# ASHBY USA, LLC

Ref: WPN: 10-3020657.02, 18-2001091.02:schwk  
NOV No. R9-2006-0135

Subject: Required Technical Report

Ashby USA  
Notice of Violation Response  
Photos  
November 28, 2006

Outfall headwall from sediment basin with rip rap for Phases 1-5  
(The Plateau)

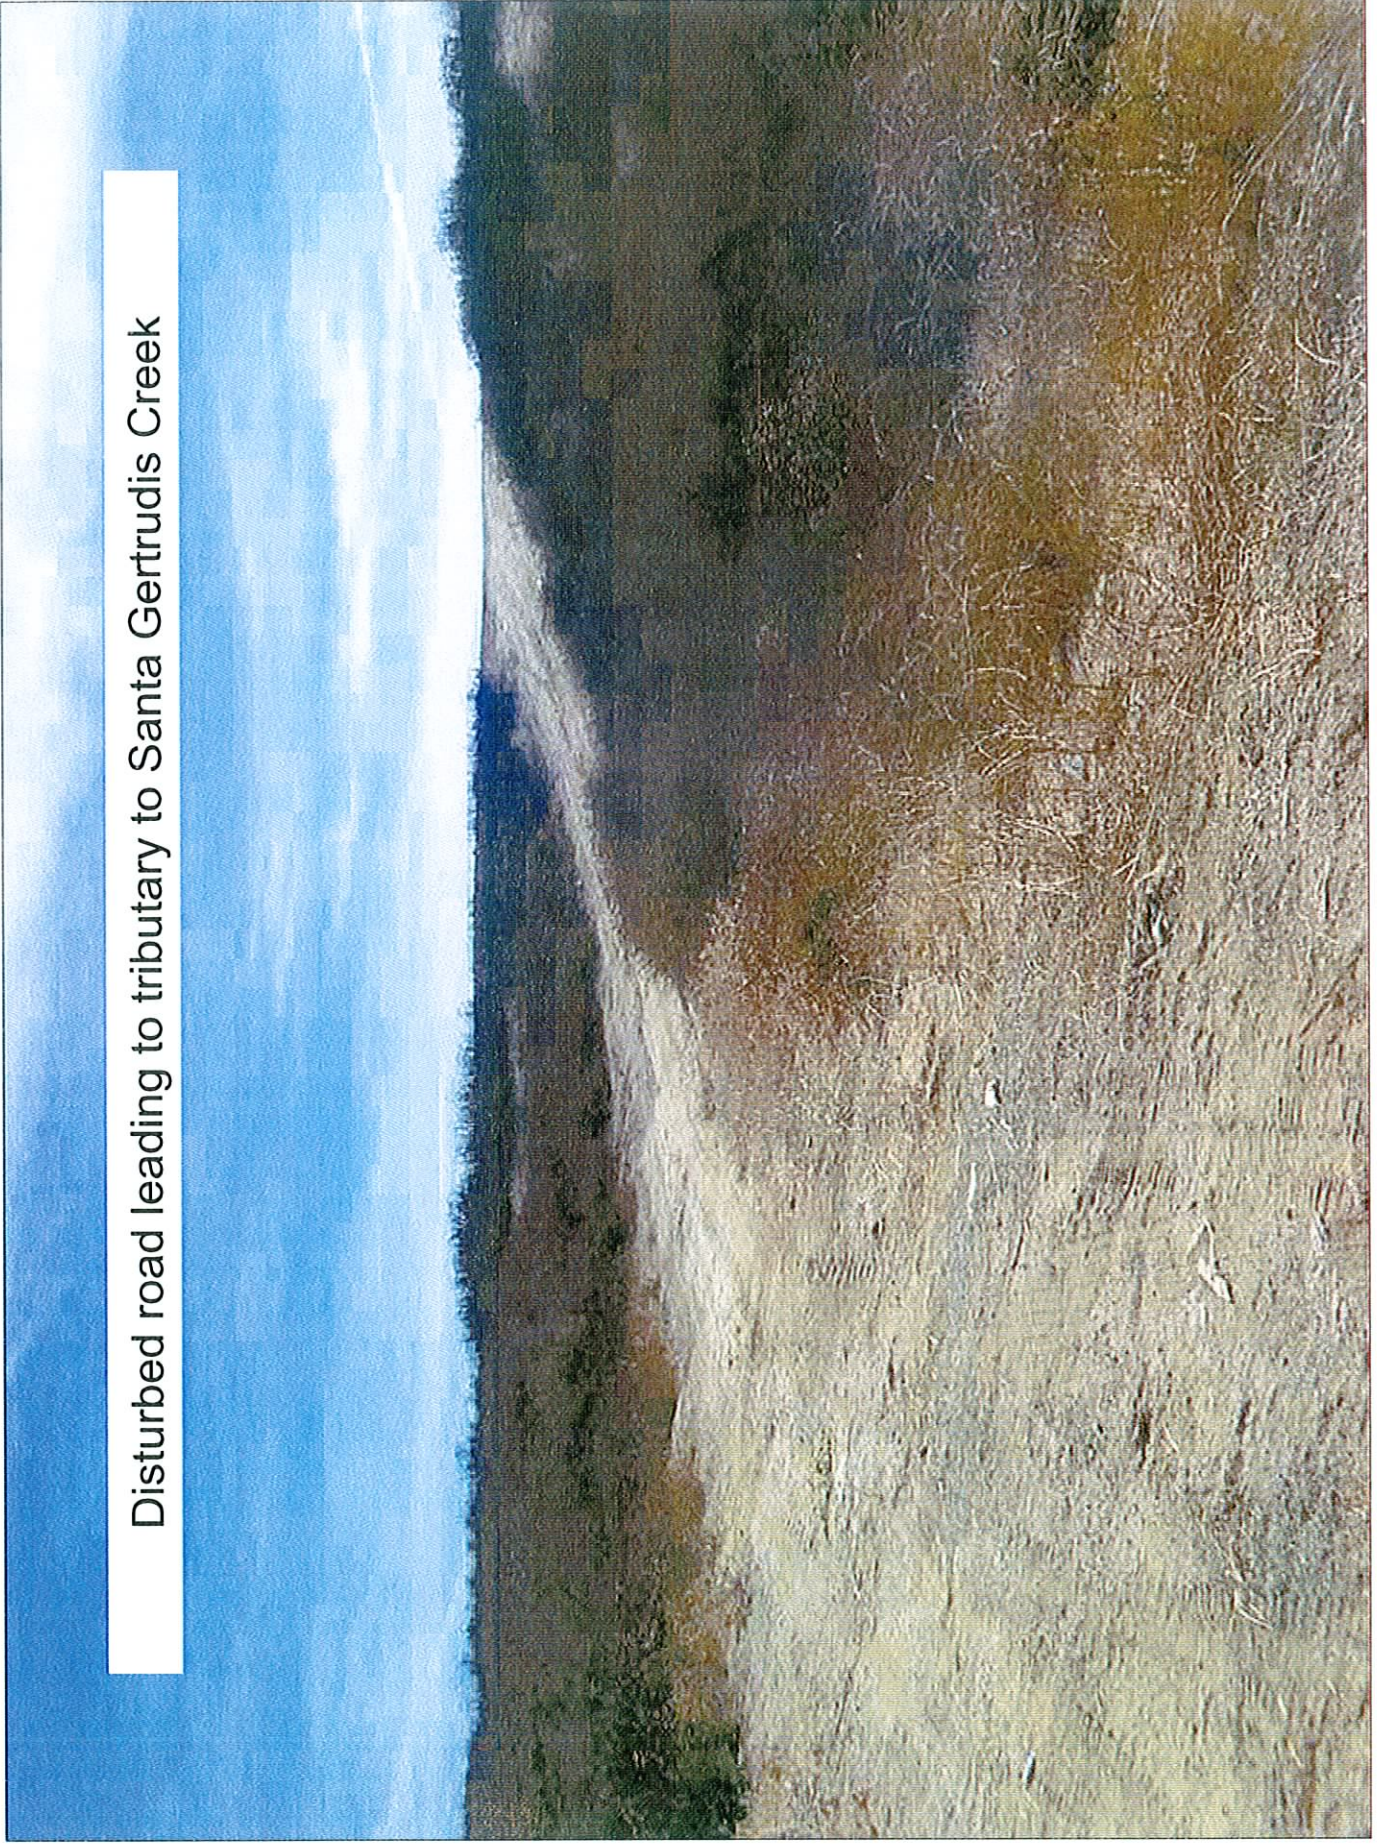
The rip rap at the headwall appeared ineffective in minimizing downstream erosion. The rip rap was covered with sediment eliminating its usefulness in reducing the velocity and energy of concentrated storm water flows from the sediment basin.

These impacts were addressed in NOV R9-2003-0197 issued April 22, 2003, NOV R9-20030392 issued on November 4, 2003, and ACL Order R9-2003-0302 issued on November 12, 2003. As a result of these violations, the following significant construction and post construction BMP's were installed per the direction of the City of Temecula, the discharge point was reduced to a 6" opening; the rip rap at the discharge point was increased. As well as the fact that all season BMP's on the plateau include Silt fencing and wattle on all lots, Storm Drain inlet protection with filter fabric with gravel bag dams. Photo 10 of the inspection report is inaccurate, as shown in the photos in exhibit "A" it is clearly identified that the outlet of the detention basin is on the Roripaugh Ranch Property, photo 10 from the NOV identifies an abandoned check dam that was placed in 2003 and it is not on the Roripaugh Ranch Project as located by the proximity of the property line fence in the background (white rail fence). As directed by the City of Temecula a secondary downstream rip rap area was added to further reduce velocity. Gravel bag check dams have also been placed between the primary and

secondary rip rap to reduce velocities for any additional seasonal flow. Please see the photos in exhibit "A" to view existing conditions.

Tributary to Santa Gertrudis Creek below headwall

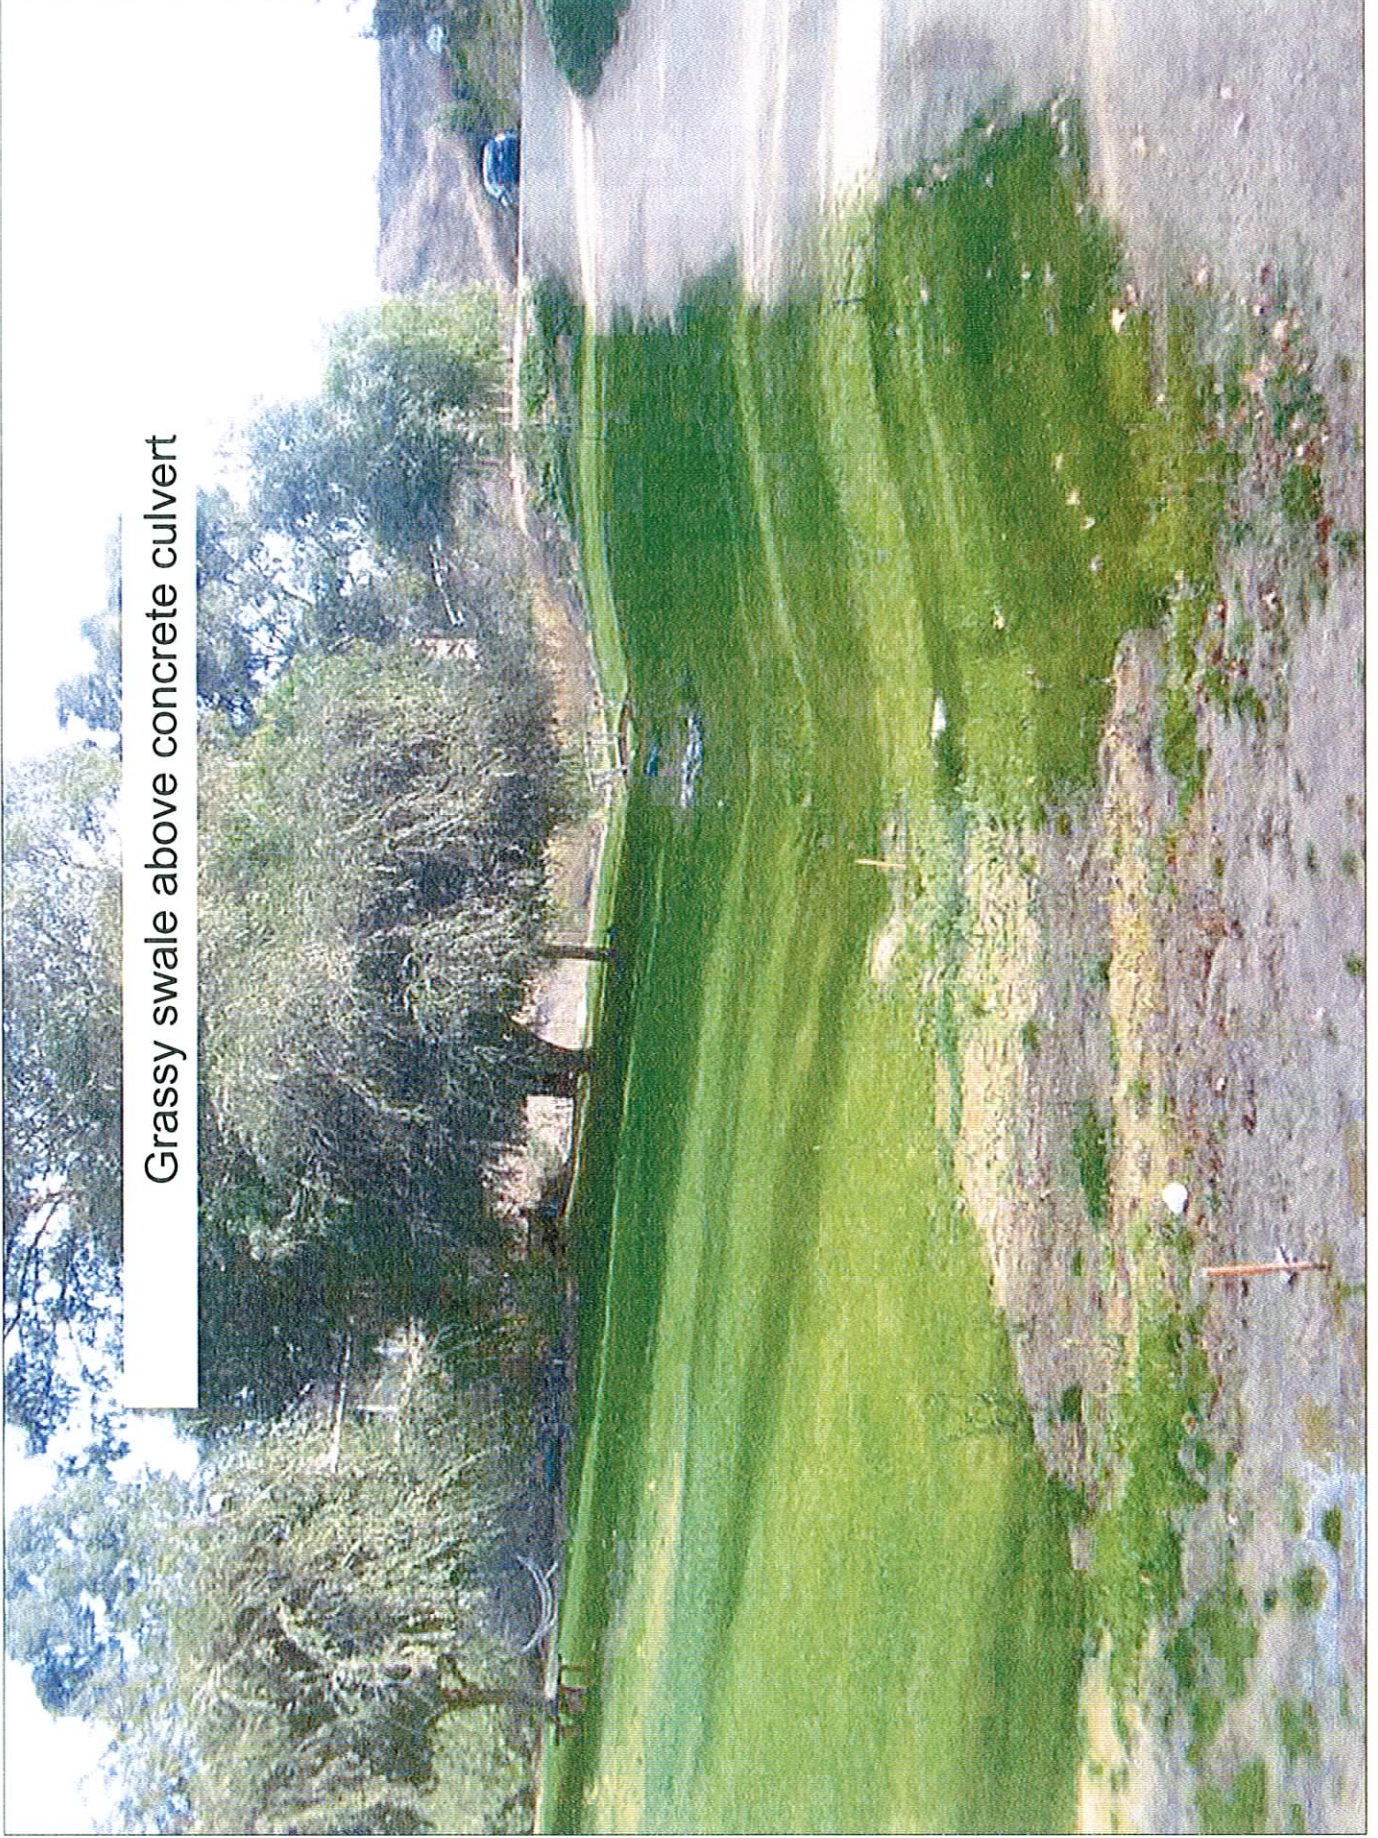
The detention basin outlet is causing downstream erosion. The WQMP includes only preliminary designs of the basin and not a detailed design of the outlet and erosion control measures, but the intent to control downstream erosion is clear in the WQMP. Erosion Control should have been addressed in the final design and installation of the detention basin.

Due to the topography of this area the discharge point of the basin is not the only source of water for this unnamed tributary to the Santa Gertrudis Creek; as shown in the attached Photo documentation (exhibit "A") there are several major erosion conditions on private property downstream that significantly contribute to the sediment within the unnamed tributary. Due to the fact that an irrigated grassy swale has been placed upstream to the complainants' property and there has been no further upstream erosion or sediment discharge since 2003 from Roripaugh Ranch (as demonstrated by the type and amount vegetation in the tributary as exemplified in exhibit "A") any nuisance flow downstream would be a direct result of irrigation run off from the adjacent property and from the private property downstream of the Roripaugh Ranch Project.
